R.E. MICHEL SUBDIVISION

APPLICATION NUMBER 3 DATE July 17, 2014

REQUEST Subdivision

DETAIL SITE PLAN

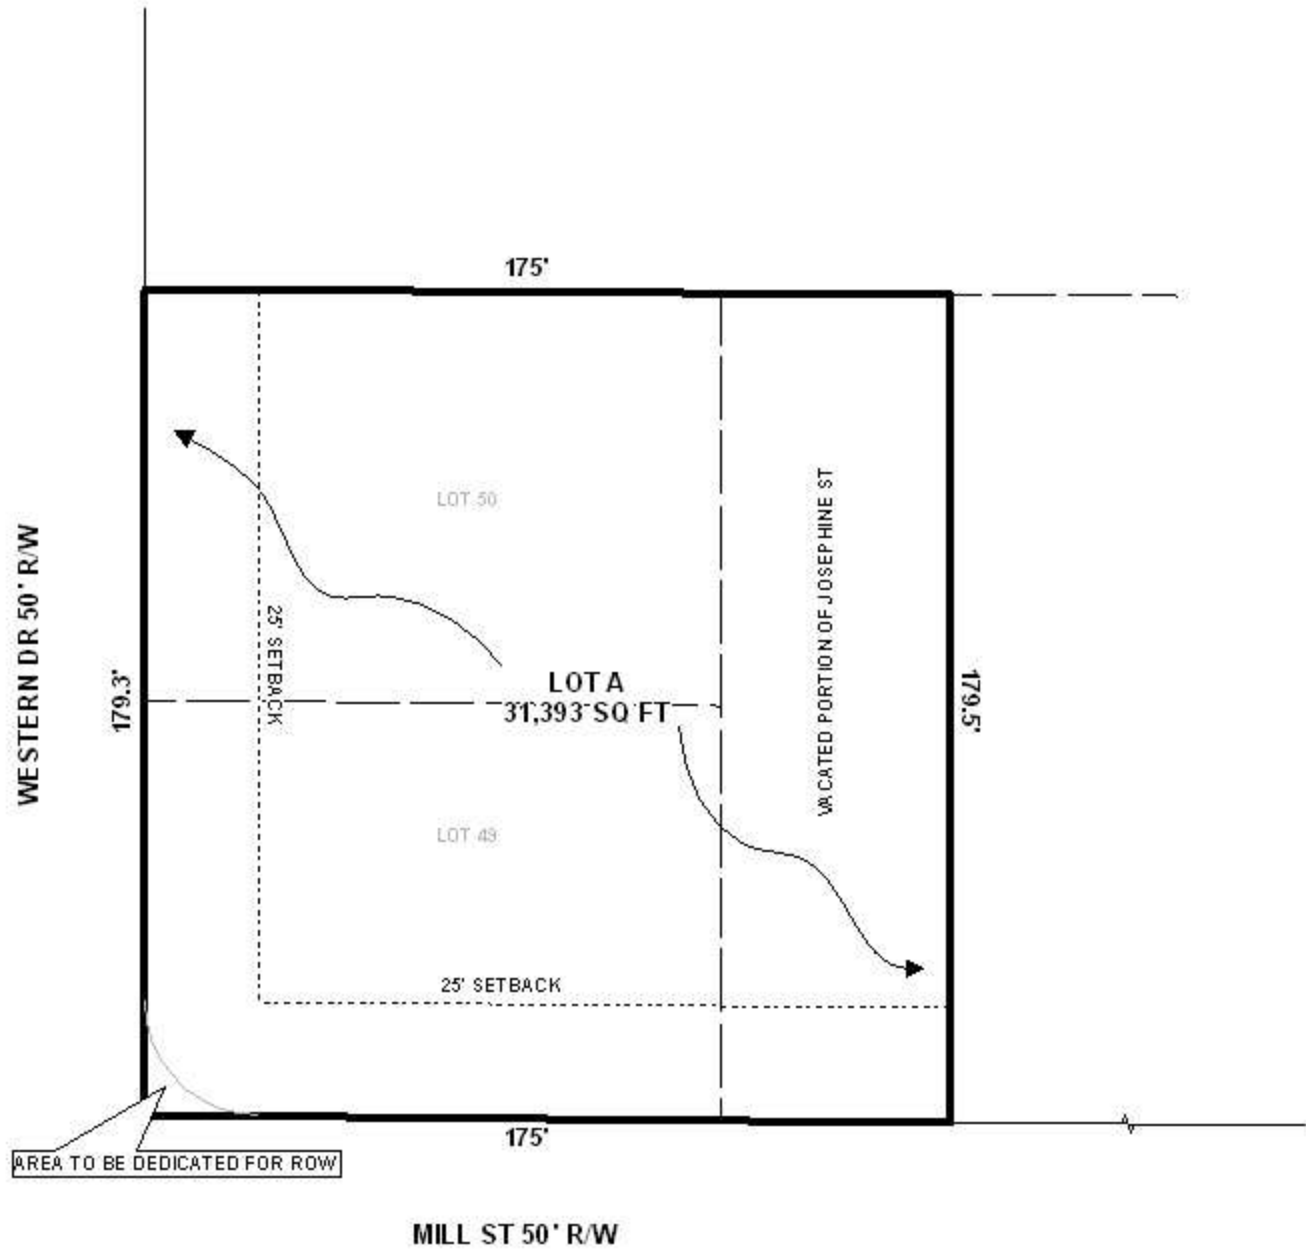
The lot size is labeled in square feet and acres, and meets the minimum size requirements of Section V.D.2. of the Subdivision Regulations. The lot size should be retained in square feet and acres on the Final Plat, if approved.

The site fronts onto Western Drive and Mill Street, both minor streets with curb and gutter, and are illustrated as having a compliant right-of-way of 50-feet; therefore no dedication should be required. Dedication of the corner radii at Western Drive and Mill Street per Section V.D.6. of the Subdivision Regulations is illustrated on the preliminary plat, and should be retained on the Final Plat, is approved. If approved, a note should be placed on the Final Plat limiting the lot to the two existing curb cuts, with the size, design, and location of the curb cut to be approved by Traffic Engineering and conform to AASHTO standards.

The preliminary plat does illustrate the 25' minimum building setback line, as required in Section V.D.9. If approved, the minimum building setback line should be illustrated on the Final Plat as well.

- 1) retention of the 25' minimum building setback line;
- 2) retention of the lot size in square feet and acres;
- 3) retention of the dedication of the corner radii at Western Drive and Mill Street;
- 4) placement of a note stating the development is limited to the existing two curb cuts with the size, location and design of all curb cuts to be approved by Traffic Engineering and conform to AASHTO standards;
